INDIANA DEPARTMENT OF TRANSPORTATION

AGENDA

August 18, 2016 Standards Committee Meeting

RE: Agenda for the August 18, 2016 Standards Committee Meeting

STANDARD DRAWING E 720-ICCA-19 CASTING TYPE 15 (ALTERNATE) FRAME, GRATE, AND CURB BOX

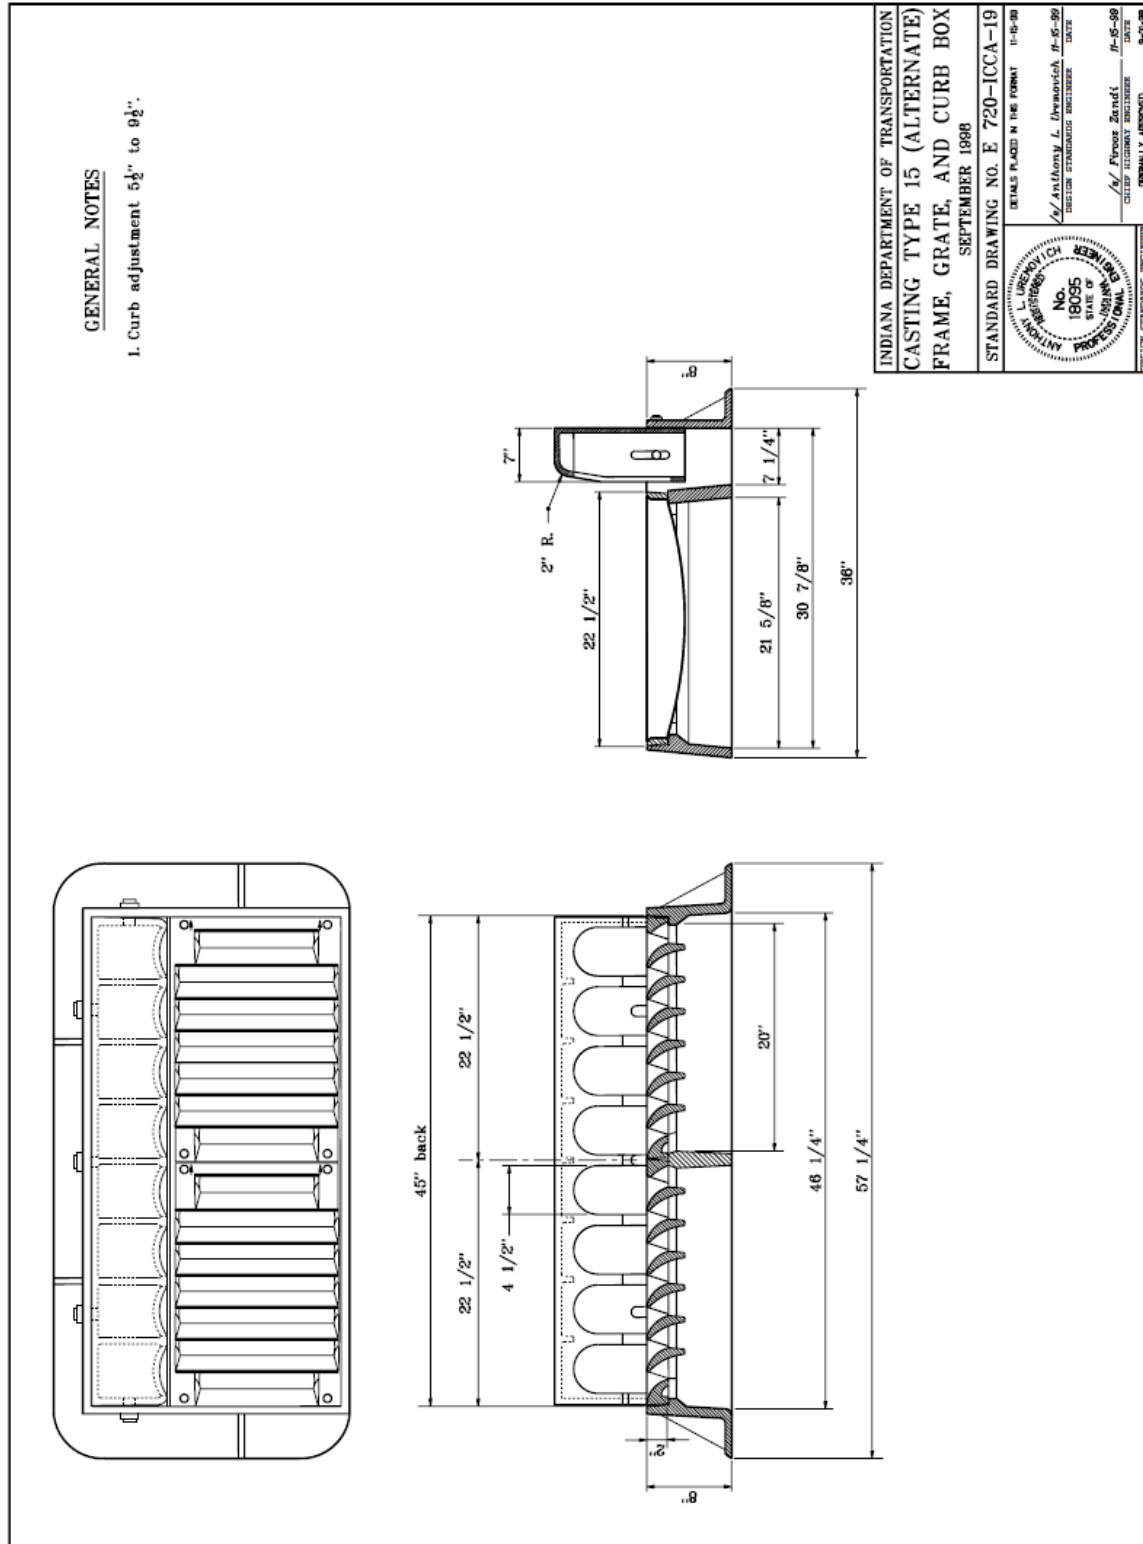
PROBLEM(S) ENCOUNTERED: Several requests from industry to allow the use of a monolithic Type 15 inlet curb casting in lieu of a separate frame and curb box.

PROPOSED SOLUTION: Immediate solution: Create brief RSP to allow use of a monolithic casting where 6" curb height is specified.
Longterm solution: Add note to Standard Drawings that allows use of monolithic casting where 6" curb height is specified.

A monolithic casting can be a more cost-effective, but is set at a fixed 6" curb height.

Where a 6-in. curb is specified, a monolithic Type 15 curb inlet casting is acceptable for use in lieu of the separate frame, grate, and curb box Type 15 casting shown on the Standard Drawings.

805-SGC0-04A SIGNAL INDICATION MOUNTED ON STEEL POLE (WITH MARKUPS)

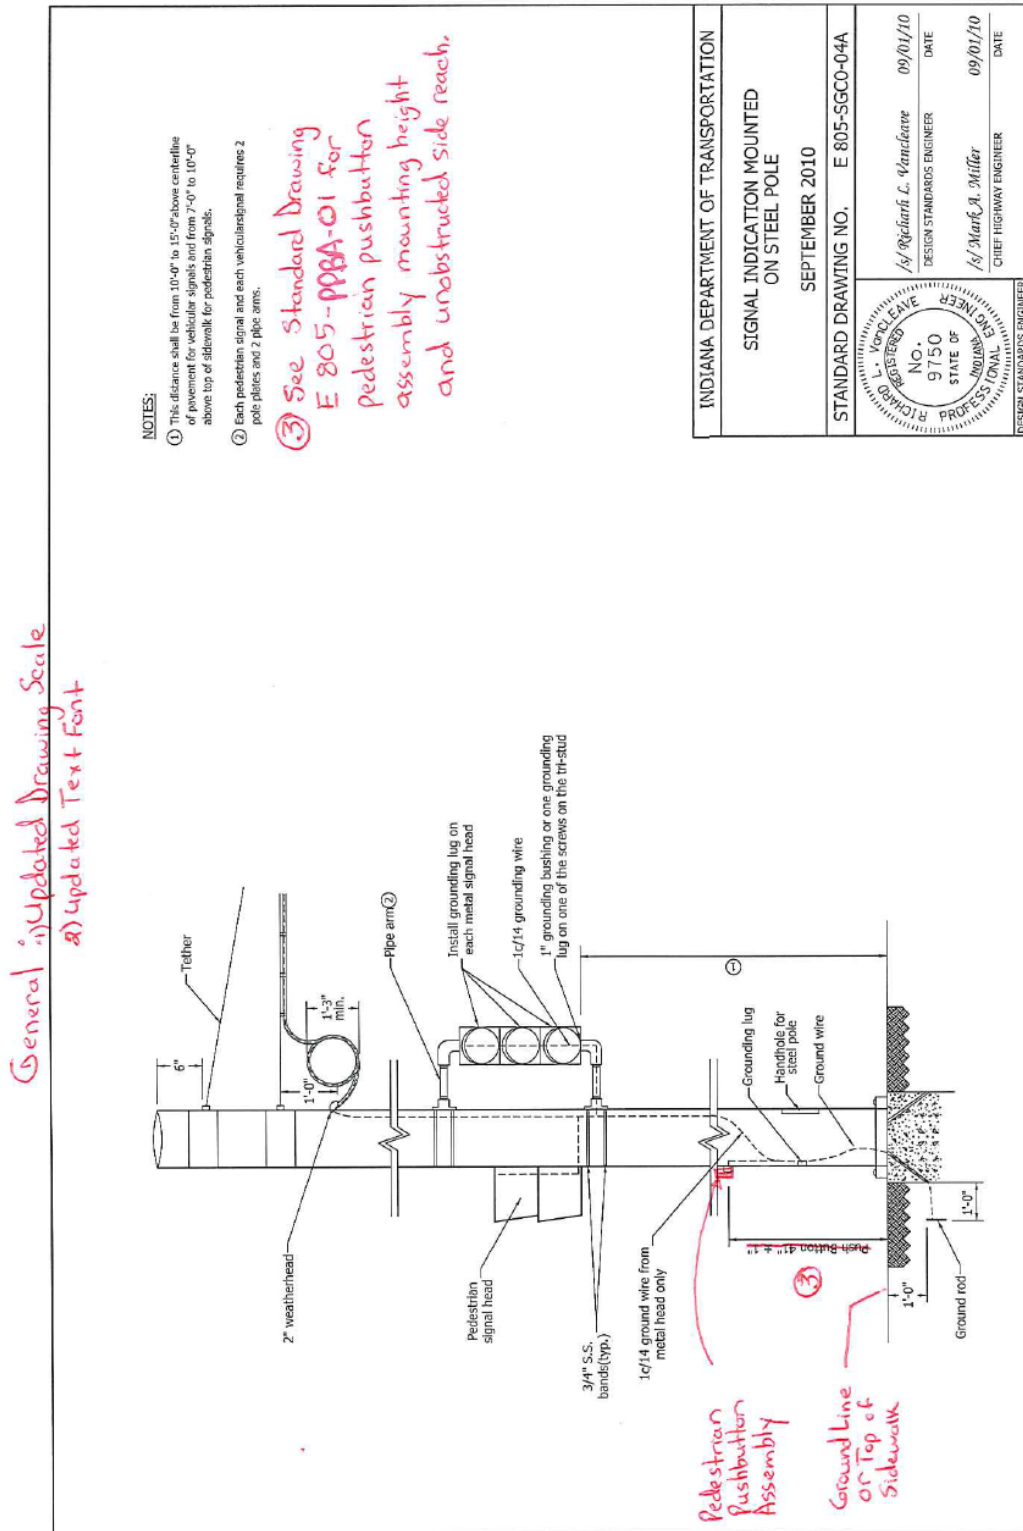
PROBLEM(S) ENCOUNTERED: After updating the 604-SWCR and SWDK Series (curb ramps and sidewalks, respectfully), the next step is to provide more details for Pedestrian Pushbutton Assemblies for both an Accessible Pedestrian Signal (APS) and a Non-APS system. An APS and Non-APS pedestrian pushbutton assembly needs to comply with the Public Rights-of-Way Accessibility Guidelines (PROWAG), the *Indiana Manual of Uniform Traffic Control Devices* (IMUTCD), and Recurring Special Provision (RSP) 805-T-201. More detail needs to be added to the *Standard Drawings* and Indiana Design Manual (IDM) for APS and Non-APS pedestrian pushbutton assemblies. For example, side reach distances and general placement of a pedestrian pushbutton assembly along the Pedestrian Access Route (PAR).

PROPOSED SOLUTION: Update existing standard drawings (E 805-SGCO Series), add new standard drawings (E 805-PPBA Series), and revise the IDM to comply with the PROWAG, IMUTCD, and RSP 805-T-201.

805-SGCO-06 CONTROLLER CABINET TYPE G ON PEDESTAL (WITH MARKUPS)

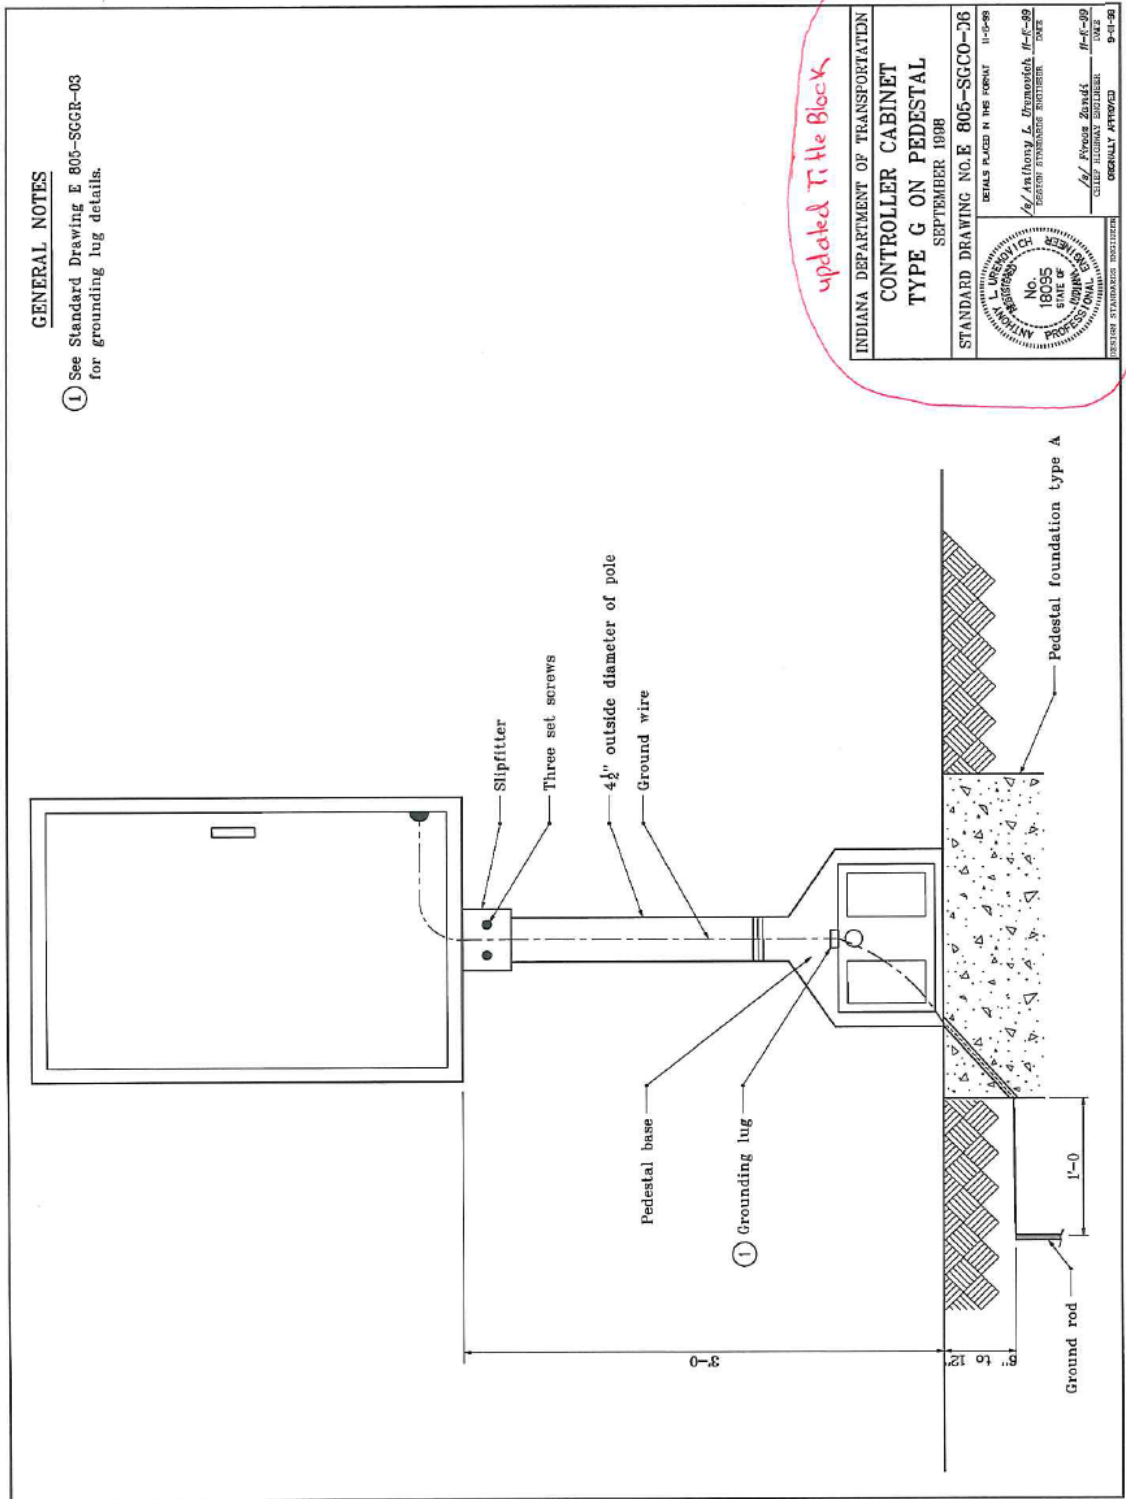
General 1) updated Text Font
 2) updated Drawing Scale

805-SGCO-04A SIGNAL SERVICE ON STEEL POLE (DRAFT)

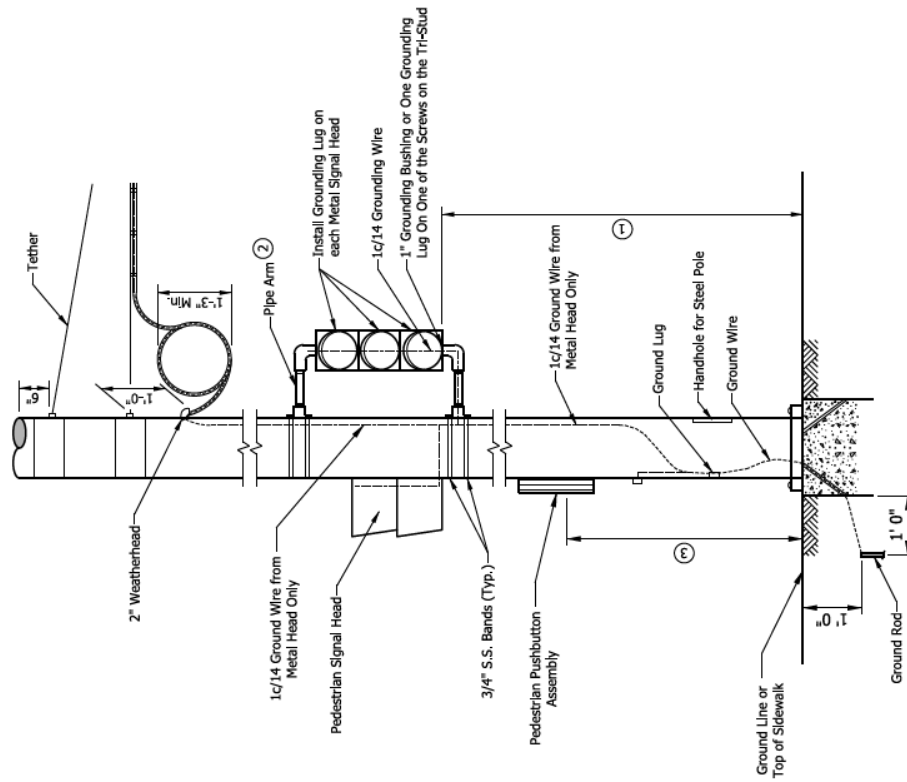
Deleted: All information is on E805-SGC0-4A or 4B

- ① This distance shall be 10'-0" to 15'-0" above centerline of pavement for vehicular signals and from 7'-0" to 10'-0" above top of sidewalk for pedestrian signals.
- ② Each pedestrian signal and each vehicular signal requires 2 pole plates and 2 pipe arms.
- ③ See Standard Drawing E 805-PP8A-01 for pedestrian pushbutton assembly mounting height and unobstructed side reach.

REVISION TO IDM FIGURE 51-1P PUSHBUTTON CLEAR SPACE

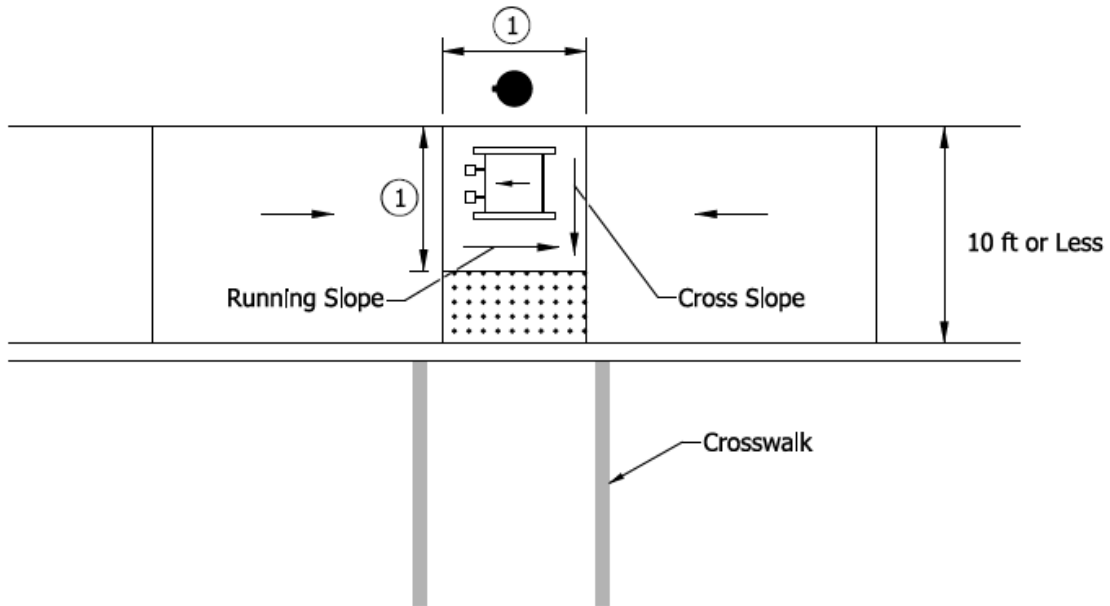
The running slope and cross slope of a clear space are based on the orientation of the pushbutton assembly. See Figure 51-1P, Pushbutton Clear Space. The running slope may be consistent with the grade of the sidewalk. The cross slope must be 2.00% maximum.

REVISION TO IDM FIGURE 51-1Q PEDESTRIAN PUSHBUTTON ASSEMBLY OUTSIDE THE BACK EDGE OF SIDEWALK, PREFERRED

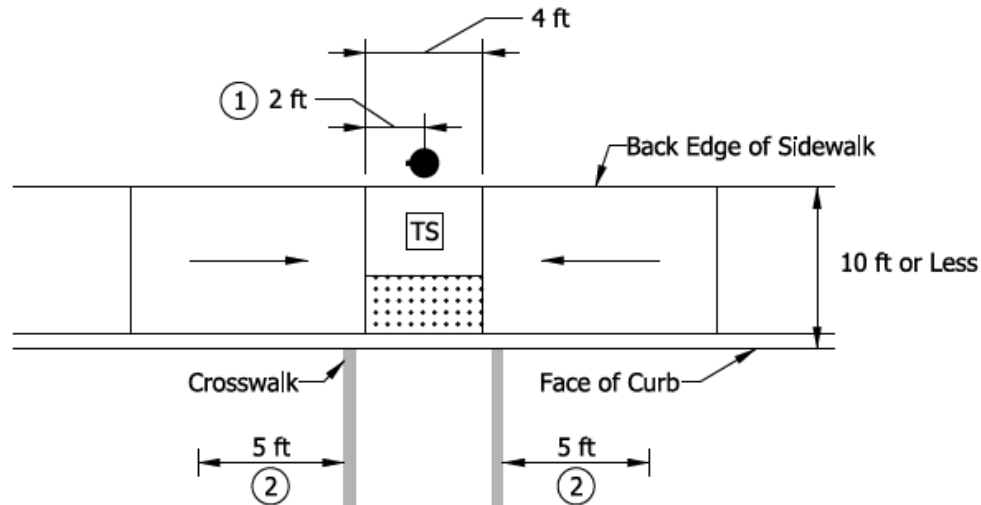
- a. Pedestrian Pushbutton Assembly Outside the Back Edge of Sidewalk. A pedestrian pushbutton assembly should not be placed more than 5 ft outside the associate crosswalk. A pushbutton assembly should be centered adjacent a pushbutton clear space. See Figure 51-1Q, Pedestrian Pushbutton Assembly Outside the Back Edge of Sidewalk, Preferred.

- ① A pushbutton assembly should be centered adjacent a pedestrian clear space. Overlapping a pushbutton clear space with a curb ramp turning space is preferred.
- ② A pushbutton assembly should not be placed more than 5 ft outside the crosswalk. A pushbutton assembly may only be placed adjacent a ramp with a running slope of 2% or less.

REVISION TO IDM FIGURE 51-1R PEDESTRIAN PUSHBUTTON ASSEMBLY WITH A SIDEWALK OR BUFFER

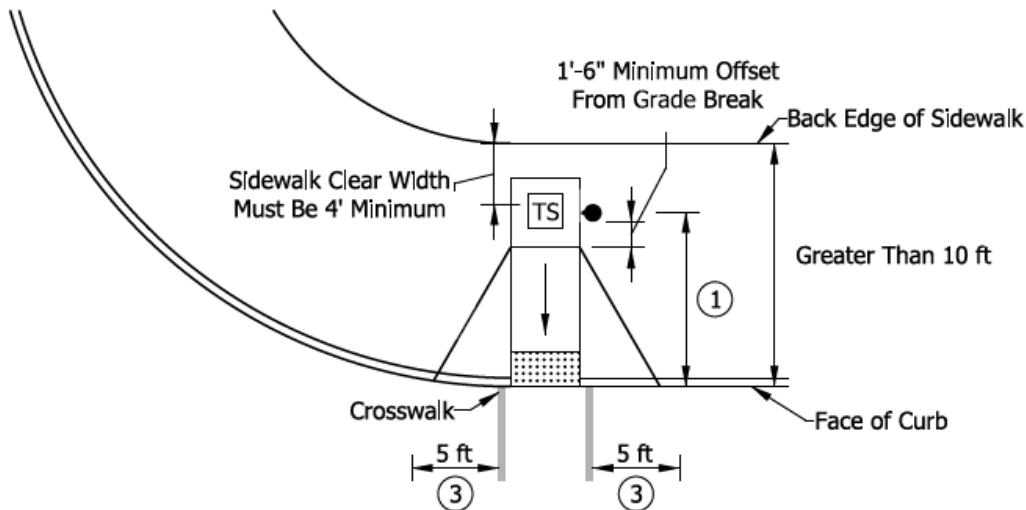
The distance from the nearest face of a pushbutton assembly to face of the curb or edge of pavement should be between 1.5 ft and 6 ft and should not be greater than 10 ft. A minimum offset of 1.5 ft from the face of curb or edge of pavement will allow a wheelchair user to remain out of traffic while actuating the pushbutton assembly. A minimum offset of 1.5 ft also provides an appurtenances-free zone along the roadway. See Section 55-5.02, Item 5.

See Figure 51-1R, Pedestrian Pushbutton Assembly Within a Sidewalk or Buffer.

- ① The distance from a pushbutton assembly to face of the curb or edge of pavement should be between 1.5 ft and 6 ft and should not be greater than 10 ft. A minimum offset of 1.5 ft from the face of curb or edge of pavement will allow a wheelchair user to remain out of traffic while actuating the pushbutton assembly. A minimum offset of 1.5 ft also provides an appurtenances-free zone along the roadway.
2. A pedestrian pushbutton assembly should be adjacent a pedestrian clear space. Overlapping the pushbutton clear space with a curb ramp turning space is preferred.
- ③ A pushbutton assembly should not be placed more than 5 ft outside the crosswalk. A pushbutton assembly may only be placed adjacent a ramp with a running slope of 2% or less.

REVISION TO IDM FIGURE 51-1S PEDESTRIAN PUSHBUTTON MOUNTING HEIGHT AND SIDE REACH

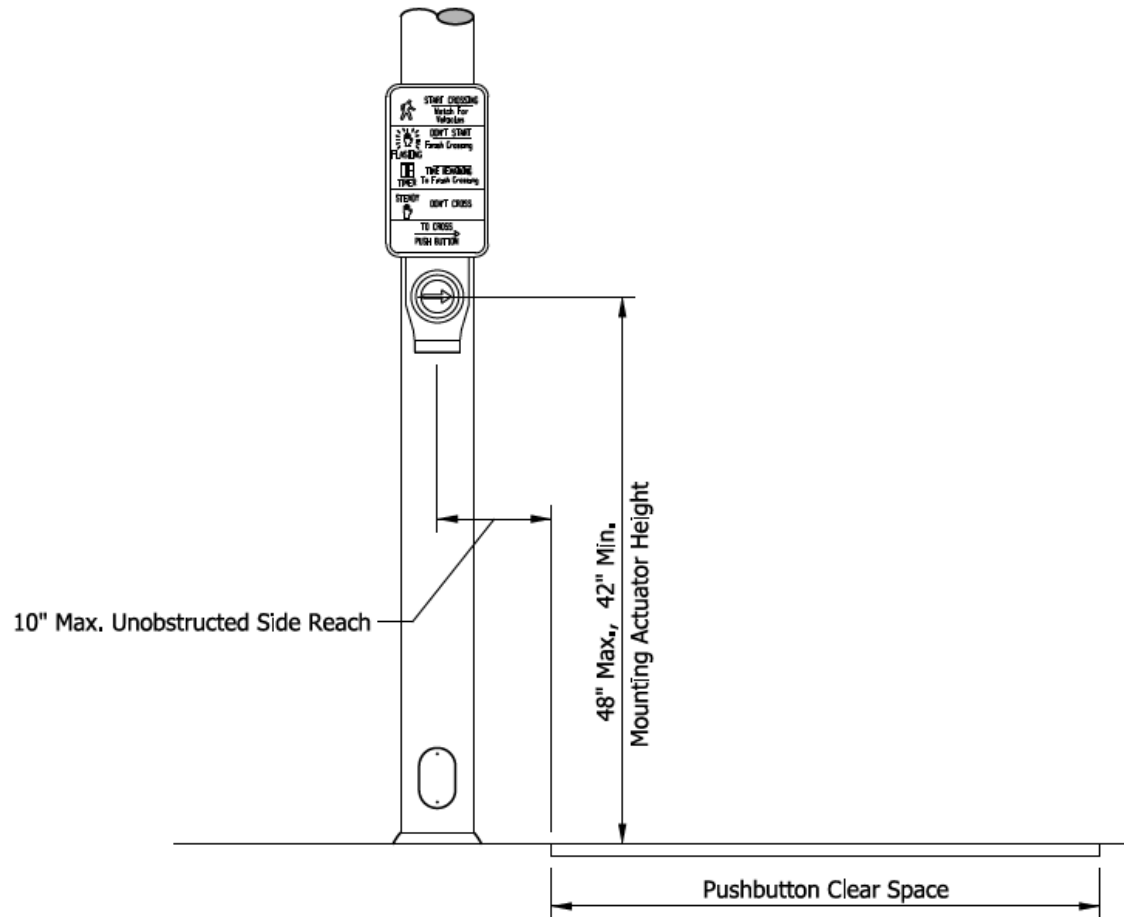
5. Mounting Height and Side Reach. [R406] The actuator of the pedestrian pushbutton assembly must be located between 42 in. and 48 in. above the pushbutton clear space and within a 10-in. unobstructed side reach. See Figure 51-1S, Pedestrian Pushbutton Assembly Mounting Height and Side Reach. Where pole placement is limited, a 6 in. or 12 in. pushbutton assembly extension may be used to meet the side reach criteria.

REVISION TO IDM FIGURE 51-1T ORIENTATION OF PEDESTRIAN PUSHBUTTON ASSEMBLY

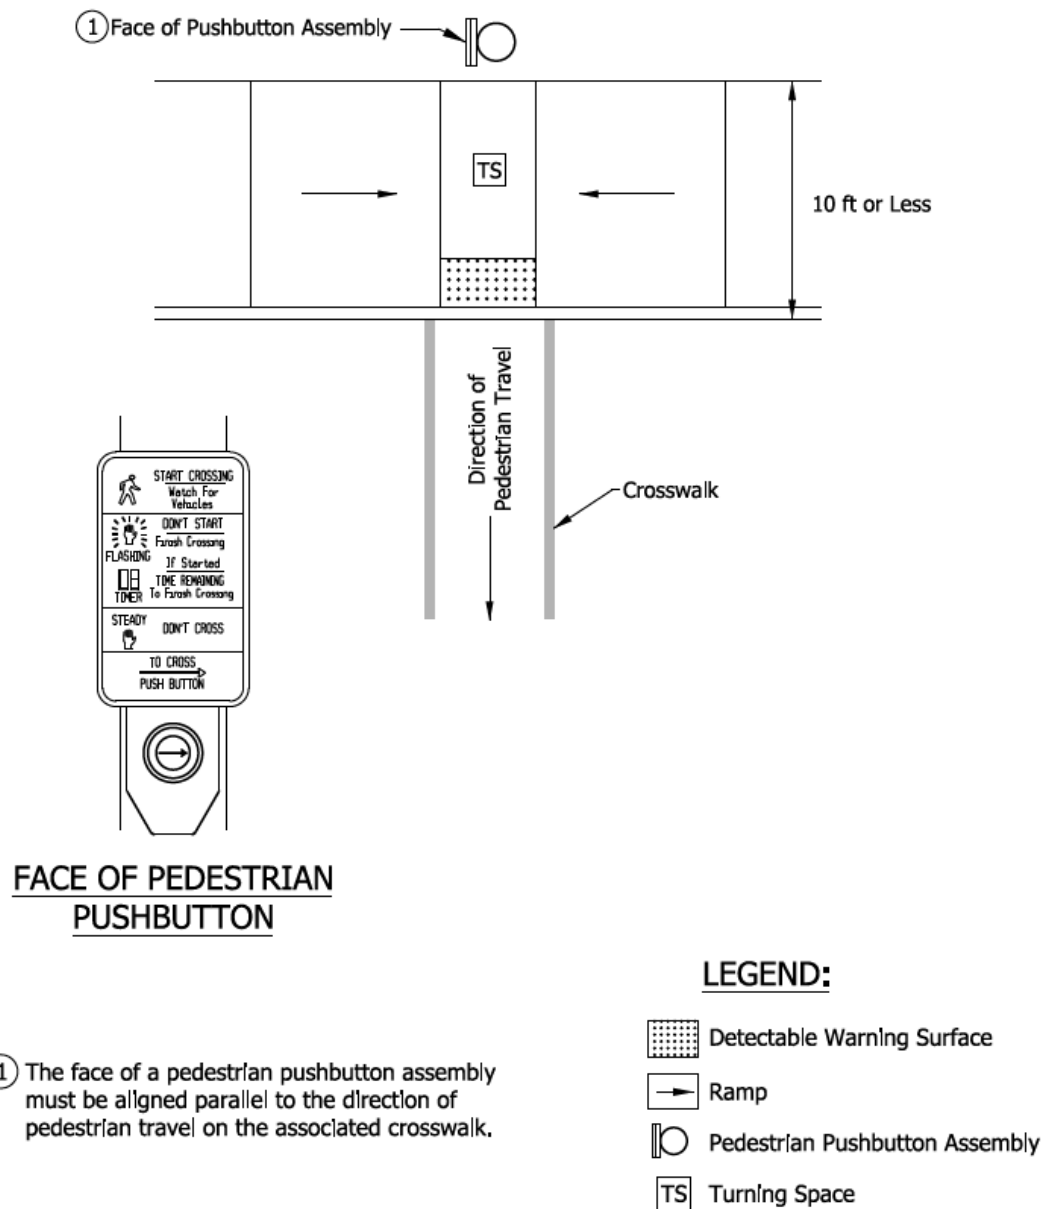
6. Orientation. The face of a pedestrian pushbutton assembly must be aligned parallel to the direction of pedestrian travel on the associated crosswalk. See Figure 51-1T, Orientation of Pedestrian Pushbutton Assembly.
